SUBJECT: NEC® Proposed Tentative Interim Amendment (TIA) No. 1692–
Public Comment Review

NFPA 70®-2023 Edition

TIA Log No.: 1692

Reference: 700.32(C), 701.32(C), and 708.54(C)

Informational Note Figure 700.32(E) Emergency System Selective Coordination.

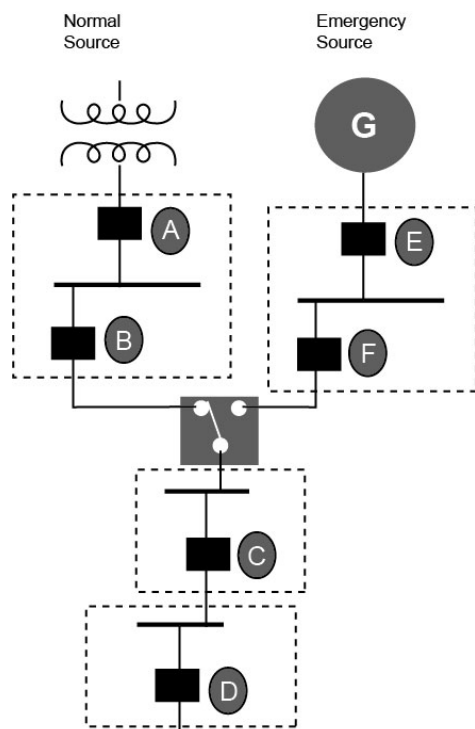
1. Revise 700.32(C) Informational Note and title of Figure for the Informational Note to read as follows:

Informational Note: See Informational Note Figure 700.32(E) for an example of how emergency system OCPDs selectively coordinate with all supply-side OCPDs.

~~OCPD D selectively coordinates with OCPDs C, F, E, B, and A.~~

~~OCPD C selectively coordinates with OCPDs F, E, B, and A.~~

~~OCPD F selectively coordinates with OCPD E.~~

~~OCPD B is not required to selectively coordinate with OCPD A because OCPD B is not an emergency system OCPD.~~

Substantiation: For each article above: The informational note and figure currently only reference part (C) of the section. When a new part (B) and (C) were added to the section, the informational note was correctly moved to the end of the section. The intent was to have this informational note and figure apply to the entire section. However, the (C) was mistakenly added by NFPA Staff to the informational note and figure after the first draft report and was not noticed by the CMP during the second draft stage of the process. NFPA was contacted that this was an entry error by staff and asked to correct as an erratum. NFPA came back with the recommendation to do a TIA to correct the entry error. This TIA seeks to remove the (C) from the informational note and figure, as recommended by NFPA.

For each article above: The informational note and figure is intended to apply to all of this section. It now can mistakenly be viewed to only apply when modifications are made to the emergency system. It is important to know that this informational note and figure applies for all emergency systems, replacements, and modifications.

OCPD D selectively coordinates with OCPDs C, F, E, B, and A.

OCPD C selectively coordinates with OCPDs F, E, B, and A.

OCPD F selectively coordinates with OCPD E.

OCPD B is not required to selectively coordinate with OCPD A because OCPD B is not an emergency system OCPD.

Informational Note Figure 701.32(G) Legally Required Standby System Selective Coordination.

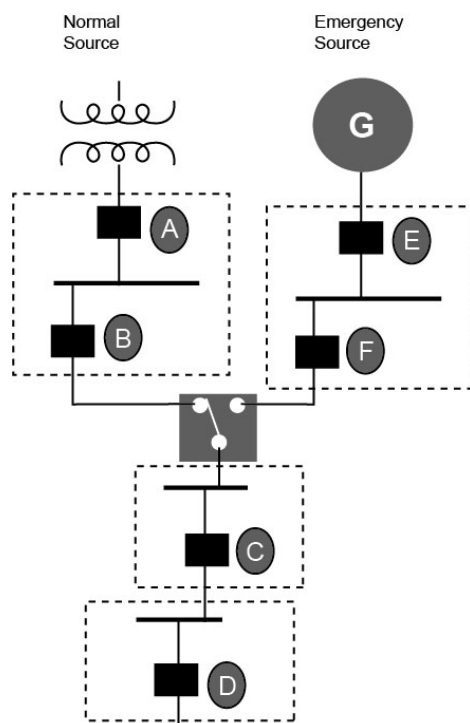
2. *Revise 701.32(C) Informational Note and title of Figure for the Informational Note to read as follows:*

Informational Note: See Informational Note Figure 701.32(G) for an example of how legally required standby system OCPDs selectively coordinate with all supply-side OCPDs.

~~OCPD D selectively coordinates with OCPDs C, F, E, B, and A.~~

~~OCPD C selectively coordinates with OCPDs F, E, B, and A.~~

~~OCPD F selectively coordinates with OCPD E.~~

~~OCPD B is not required to selectively coordinate with OCPD A because OCPD B is not a legally required standby system OCPD.~~

OCPD D selectively coordinates with OCPDs C, F, E, B, and A.

OCPD C selectively coordinates with OCPDs F, E, B, and A.

OCPD F selectively coordinates with OCPD E.

OCPD B is not required to selectively coordinate with OCPD A because OCPD B is not a legally required standby system OCPD.

Informational Note Figure 708.54(E) Critical Operations Power System Selective Coordination.

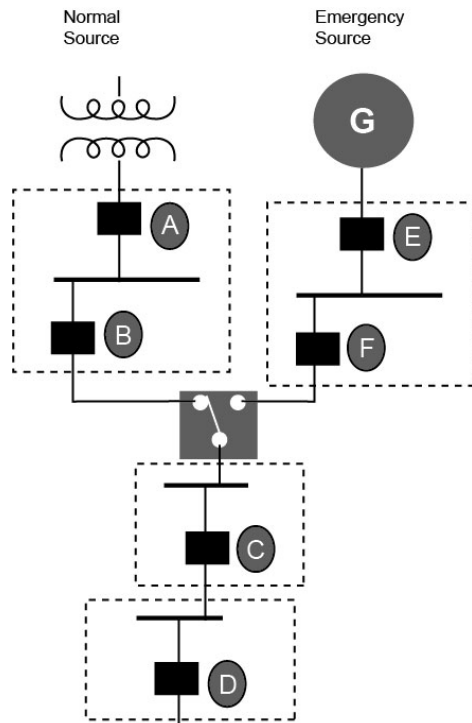
3. *Revise 708.54(C) Informational Note and title of Figure for the Informational Note to read as follows:*
- 708.54(A) General.** Critical operations power system(s) overcurrent protective devices (OCPDs) shall be selectively coordinated with all supply-side and load-side OCPDs.

Informational Note: See Informational Note Figure 708.54(E) for an example of how critical operations power system OCPDs selectively coordinate with all supply-side OCPDs.

~~OCPD D selectively coordinates with OCPDs C, F, E, B, and A.~~

~~OCPD C selectively coordinates with OCPDs F, E, B, and A.~~

~~OCPD F selectively coordinates with OCPD E.~~

~~OCPD B is not required to selectively coordinate with OCPD A because OCPD B is not a critical operations power system OCPD.~~

OCPD D selectively coordinates with OCPDs C, F, E, B, and A.

OCPD C selectively coordinates with OCPDs F, E, B, and A.

OCPD F selectively coordinates with OCPD E.

OCPD B is not required to selectively coordinate with OCPD A because OCPD B is not a critical operations power system OCPD.
